# UNITED STATES PATENT AND TRADEMARK OFFICE

APPLICATION NO.	FILING DATE	FIRST NAMED INVENTOR	ATTORNEY DOCKET NO.	CONFIRMATION NO.
10/816,986	04/02/2004	Yoshihiro Isogai	5000-5163	2010

<b>Office Action Summary</b>	Application No. 10/816,986	Applicant(s) ISOGAI, YOSHIHIRO	
	Examiner Gregg Cantelmo	Art Unit 1795

## **DETAILED ACTION**

第 3 図

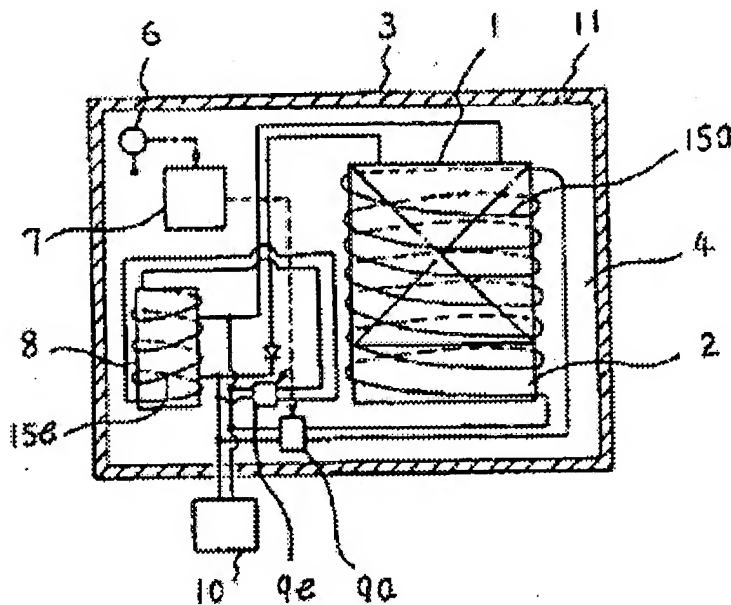
JP '967 discloses a hybrid system comprising: a first heating device 15b that heats the battery 8, a second heating device 15a that heats the fuel battery 1 using electricity of the battery and a control device 7 connected to switches 9a and 9b which is configured to selectively drive the heating system of the fuel cell (Fig. 3 as applied to claims 1 and 19).

The fuel battery 1 is a stack of cells. (as applied to claim 3).

The first heating device about the battery is driven by electricity generated by the battery (as applied to claim 4).

The heater 15a is mounted onto the fuel cell stack 1 (as applied to claim 20).
